Product/Process Change Notice (PCN)

<p>PCN Number: PCN_AsSPARO_20241123</p> <p>Affected Series: WA-SPARO</p> <p>Affected Order Codes: see table below</p> <p>PCN Date: 2024-08-23 (YYYY-MM-DD)</p> <p>Effective Date: 2024-11-23 (YYYY-MM-DD)</p>	<p>Change Category:</p> <p><input type="checkbox"/> Equipment/Location</p> <p><input checked="" type="checkbox"/> General Data</p> <p><input type="checkbox"/> Material</p> <p><input type="checkbox"/> Process</p> <p><input type="checkbox"/> Product Design</p> <p><input type="checkbox"/> Shipping/Packaging</p> <p><input type="checkbox"/> Supplier</p> <p><input type="checkbox"/> Software</p>
<p>Contact: Product Management</p> <p>Phone: +49 (0) 7942 - 945 5001</p> <p>Fax: +49 (0) 7942 - 945 5179</p> <p>E-Mail: pcn.eican@we-online.com</p>	<p>Datasheet Change:</p> <p><input checked="" type="checkbox"/> Yes <input type="checkbox"/> No</p> <p>Attachment:</p> <p><input type="checkbox"/> Yes <input checked="" type="checkbox"/> No</p>

Before change	After change

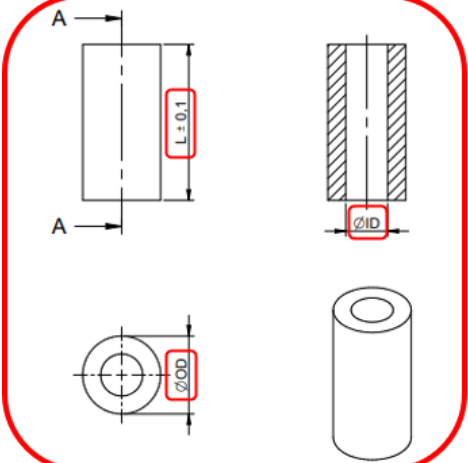
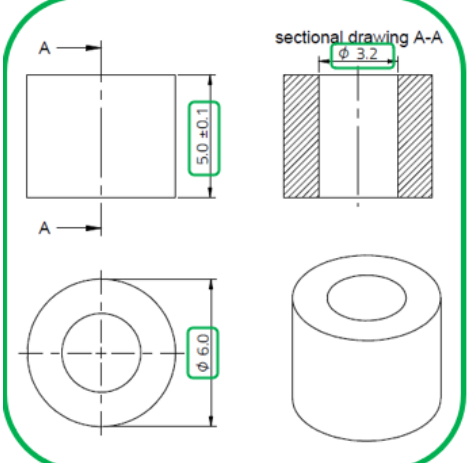
Because of a database mismatch, Würth Elektronik eiSos update 3D models & datasheets.
 All products/LOT will be affected by this change. This is a 3D model & datasheet correction only.
 There will be no change in form, fit, function, quality or reliability of the product.

Updated dimensions and 3D models e.g. drawing section below
